Re: Barton Village Hydroelectric Project, FERC No. 7725, License Articles 403 and 404-Flow Management and Impoundment/Flow Monitoring Plan.

BARTON VILLAGE HYDROELECTRIC PROJECT
FERC Project No. 7725

FLOW MANAGEMENT AND IMPOUNDMENT/FLOW MONITORING PLAN
LICENSE ARTICLES 403 and 404

RE: Barton Village Hydroelectric Project – FERC No. 7725
Articles 403/404 *Flow Management and Impoundment/Flow Monitoring Plan*

FIGURE 1

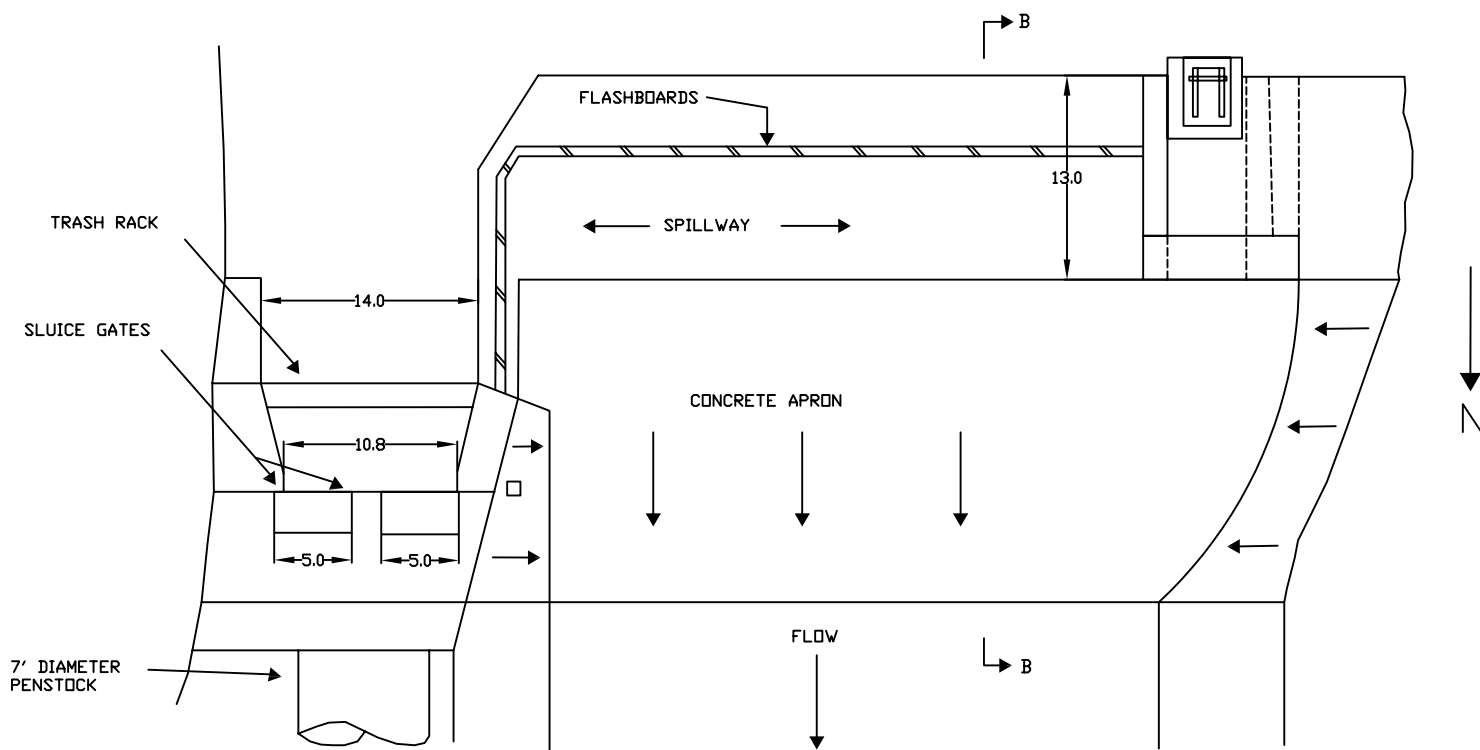
1. The final Plan should include drawings showing both plan and section views of the release structures (slide gate, spillway and fishway slot), along with pertinent elevations.
2. The Plan should explain why a sensor will be located in the tailrace of Unit 1 (versus Unit 2). Also, because of potential head losses downstream of the trashracks, we recommend installing the headpond sensor upstream of the trashracks in a stilling well.

The primary water conveyance structure at the dam is the flashboard topped spillway with a total length of approximately 53 feet (see Figure 1). In addition, the west gate structure consists of three conveyances that allow water to pass into the bypass reach as well. These conveyances include a 5-foot by 5-foot low-level slide gate with a manual hoist. The sill elevation of the gate is approximately 1131.94 feet, msl. Directly above the slide gate, there are two ungated arched openings. There is a 5 foot wide by 5 foot high opening and a smaller 1.9 foot wide by 5 foot high opening. Both of the ungated openings are without flashboards and have sill elevations of approximately 1139.94 feet, msl.
